Access Compliance Report

(Curb Ramps)

Intersection ID: 18755	Main Street: MATADOR_LN	Cross Street: SELWYN_AV	Location: W
ADA ID: 16565435886B	Ramp Type: Para	Initial Pass/Fail: Fail	Overall Compliance: No
Severity Score: 13.75			
Codes/Mitigation Info/Possible Solution		Field Measurements/Component Compliance

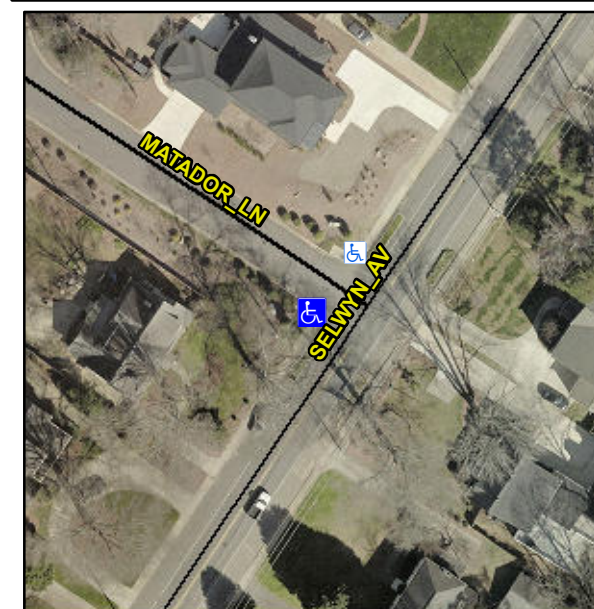
LT RP < 5%

PROW/ADA:

R304.3.2, R304.5.3

Remove & Replace Entire Ramp.
